ATTACHMENT 1

PROPOSED TECHNICAL SPECIFICATION CHANGES FOR NORTH ANNA UNIT 2

DISCUSSION OF PROPOSED CHANGES

1. Replacement of CAOC Axial Flux Difference (AFD) Limits with RPDC Limits (Sections 3.2.1, 4.2.1, B3/4.2.1 and 3.10.2)

Figure 3.2-1 AXIAL FLUX DIFFERENCE LIMITS AS A FUNCTION OF RATED THERMAL POWER

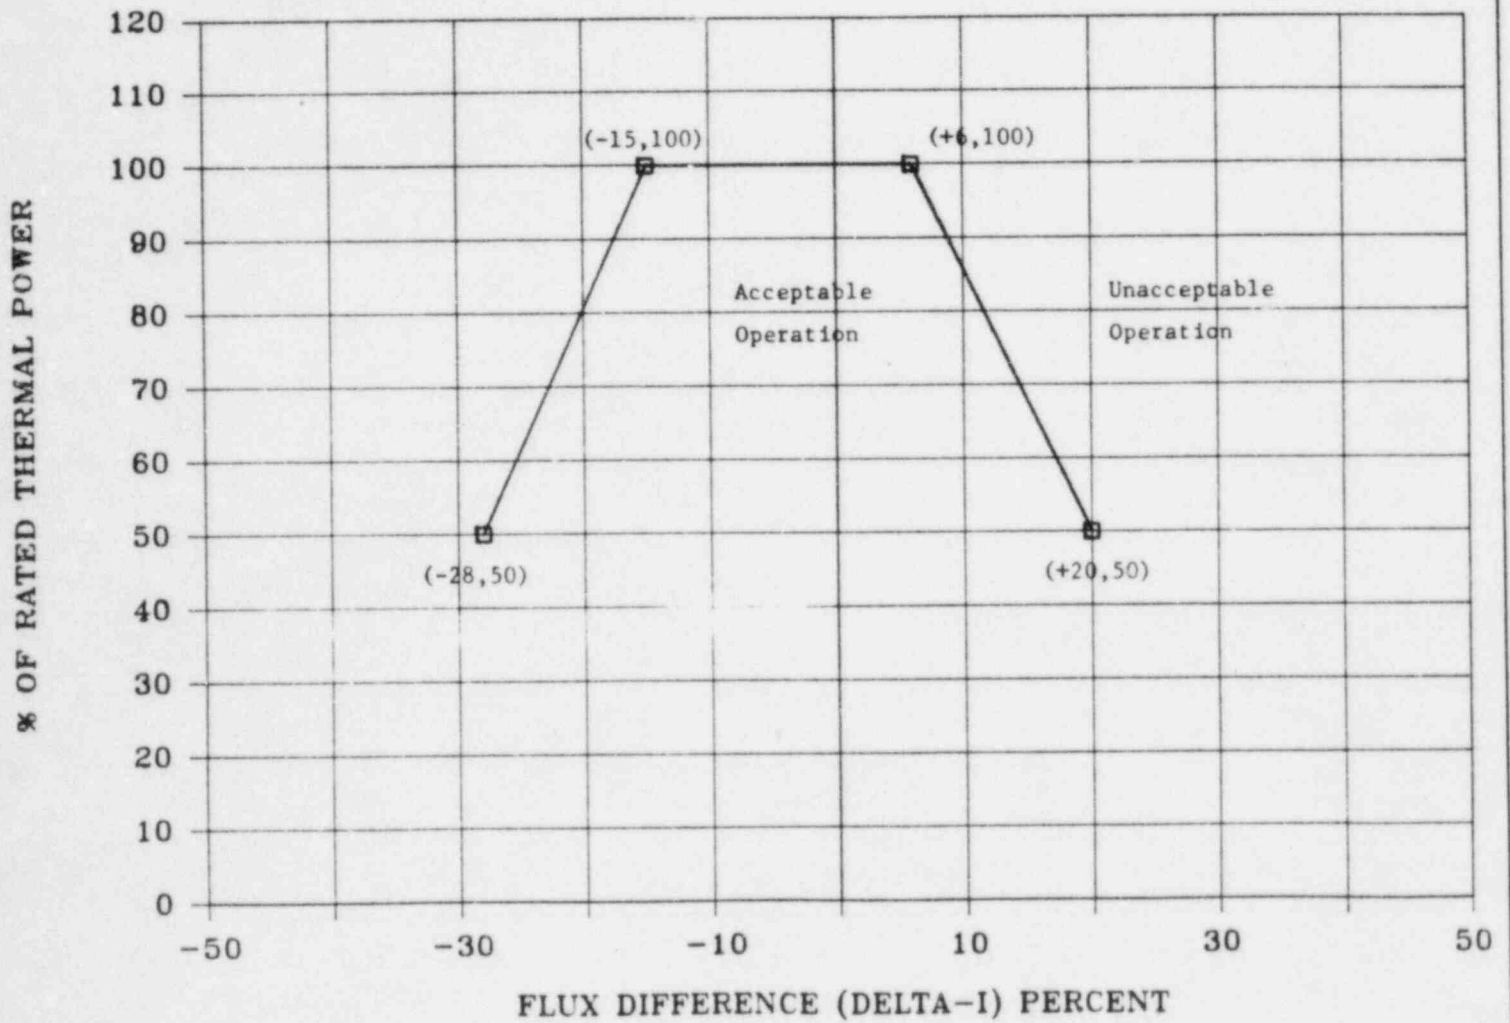
All references to the indicated AFD target and operating band have been deleted, replacing them with AFD limits consistent with the RPDC methodology of Reference 2. In the Action Statement associated with the Limiting Condition for Operation (LCO), the requirement to restore the indicated AFD to within the limits within 15 minutes has been retained. If this requirement is not met, power must be reduced to less than 50% of rated within 30 minutes. As discussed in Reference 2, maintaining the AFD within the prescribed limits will ensure that: 1) the maximum expected $FQ(Z)$ will not exceed the limit specified in Section 3.2.2; 2) the axial power

distribution in the core will not fall outside the range of preconditions used to ensure that the overtemperature delta-T and overpower delta-T functions provide adequate core protection ; and 3) the UFSAR analysis of the Complete Loss of Flow event remains limiting. The lower limit of 50% power on imposing AFD limits is consistent with the current Technical Specifications.

Reference to the Special Test Exception of Section 3.10.2 has been removed from Section 3.2.1. Thus the specified axial flux difference limits will apply during the performance of physics tests.

3.2.1 The indicated AXIAL FLUX DIFFERENCE (AFD) shall be maintained within the allowed operational space defined by Figure 3.2-1.

- a. With the indicated AXIAL FLUX DIFFERENCE outside of the Figure 3.2-1 limits,
 - 1.) Either restore the indicated AFD to within the Figure 3.2-1 limits within 15 minutes, or
 - 2.) Reduce THERMAL POWER to less than 50 % of RATED THERMAL POWER within 30 minutes and reduce the Power Range Neutron Flux - High Trip setpoints to less than or equal to 55 percent of RATED THERMAL POWER within the next 4 hours.
- b. THERMAL POWER shall not be increased above 50% of RATED THERMAL POWER unless the indicated AFD is within the Figure 3.2-1 limits.

4.2.1.2 The indicated AFD shall be considered outside of its limit when at least 2 OPERABLE excore channels are indicating the AFD to be outside of the limit shown in Figure 3.2-1.
